Access Compliance Report

Public Rights-of-Way

Intersection ID: 8847	Main Street: E_SUGAR_CREEK_RD	Cross Street: N_TRYON_ST	Location: SW
ADA ID: E43F9E161945	Ramp Type: Perp	Initial Pass/Fail: Fail	Overall Compliance: No
Severity Score: 18.75			
Codes/Mitigation Info/Possible Solution		Field Measurements/Component Compliance

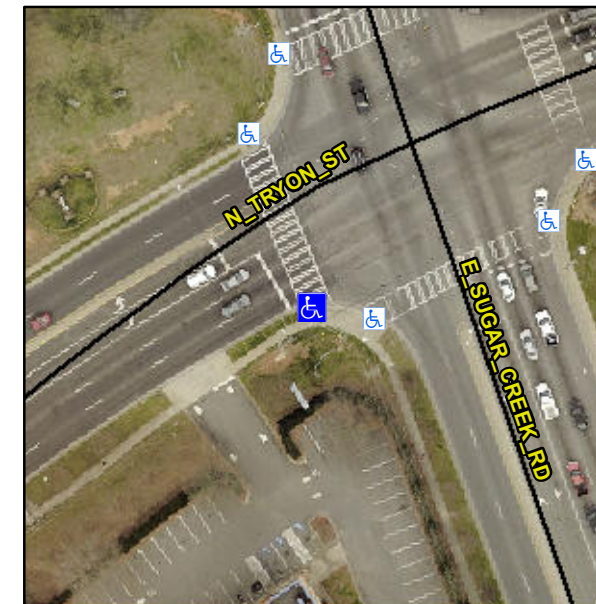
Not Found, R304.5.1, R304.5.3

Compliance	Description	Data	Compliance	Description	Data
N/A	Ramp Length (in)	68.0	Yes	Ramp Slope (%)	5.4
No	Ramp Width (in)	35.0	No	Ramp XSlope (%)	3.7
N/A	Flare Type LT	N/A	N/A	Flare Type RT	N/A
N/A	Flare Slope LT (%)	N/A	N/A	Flare Slope RT (%)	N/A
N/A	Flare Traversable LT?	N/A	N/A	Flare Traversable RT?	N/A
N/A	Landing Length (in)	N/A	N/A	DWS Provided?	N/A
N/A	Landing Width (in)	N/A	N/A	DWS Contrast?	N/A
N/A	Landing Slope (%)	N/A	N/A	DWS Length (in)	N/A
N/A	Landing X Slope (%)	N/A	N/A	DWS Full Width?	N/A
N/A	Landing Curb? (Y/N)	N/A	N/A	DWS Offset (in)	N/A
N/A	Shared Landing?	N/A			
N/A	Gutter Ponding?	N/A	N/A	Gutter Slope (%)	N/A
N/A	Gutter Lip Ht (in)	N/A	N/A	Gutter X Slope (%)	N/A
N/A	Painted X Walk1?	Yes	N/A	Painted X Walk2?	N/A
	X Walk 1 Direction	To N		X Walk 2 Direction	N/A
N/A	X Walk 1 Width (in)	178.0	N/A	X Walk 2 Width (in)	N/A
	X Walk 1 Slope (%)	1.8		X Walk 2 Slope (%)	N/A
	X Walk 1 X Slope (%)	0.1		X Walk 2 X Slope (%)	N/A

Remove & Replace Entire Ramp.
